Glosten

PROJECT MEMORANDUM

Matanuska Cabin Deck Arrangement Alternatives

1 November 2022

○ **Figure 1** Sketch of alternate arrangement to cabins on the Matanuska Cabin Deck. Developed from vessel General Arrangement drawing. Blue arrow shows a dead end corridor remaining after the removal of the inboard cabins.

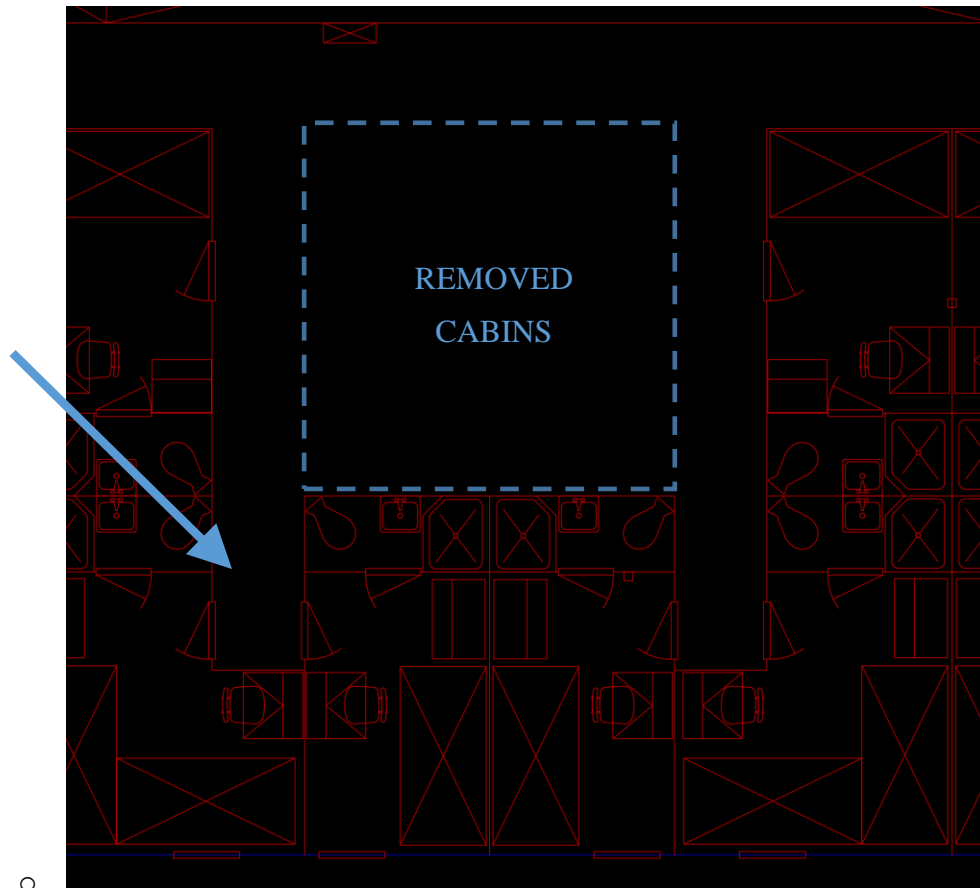
- Added: removing the cabins as sketched in the email attachment (Reference 1) will not remove the dead end corridors without additional modifications to the retained cabins. SOLAS definition of “dead-end corridor” is a recess that has a depth dimension that is longer than its width. A solution is likely possible that complies with the SOLAS requirements, but not as simple as removing pairs of inboard cabins. See figure below.

Figure 2 Alternative option for cabin deck layout. Joining pairs of outboard cabins and removing a pair of toilet/shower spaces could allow for new longitudinal passageways that would eliminate the existing dead-end corridors.

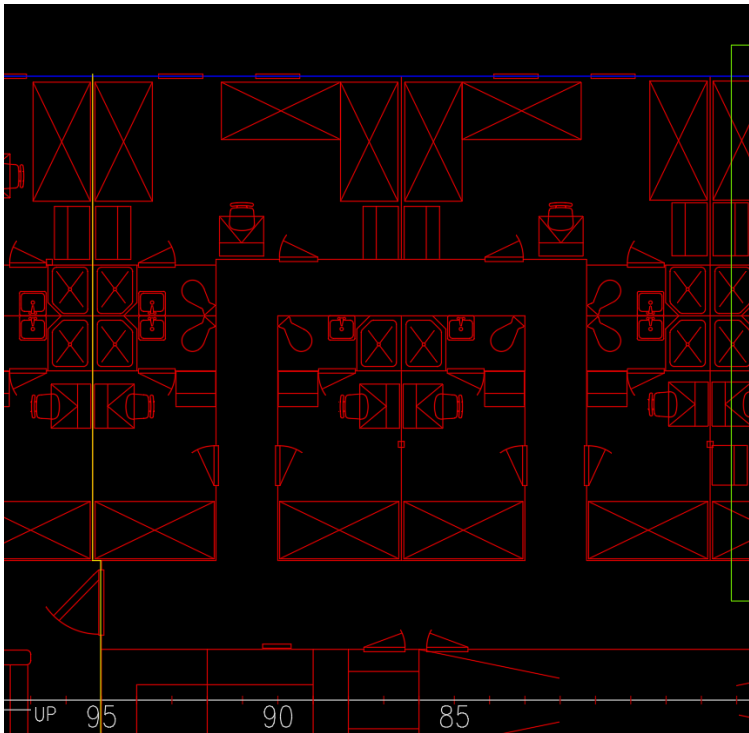
If the State has a strong desire to reduce the Cabin Deck modification scope of work, an alternative exists that could balance cabin capacity and reduced modification scope. See sketch below.

1. Retain inboard cabins, largely unmodified.
2. Combine fore/aft pairs of outboard cabins to make 4-6 person suites.
3. Remove one pair of fore/aft toilet/shower spaces to make a passageway between transverse corridors.
4. This concept has not been strongly vetted, but could have value should AMHS decide to pursue a reduce scope option.
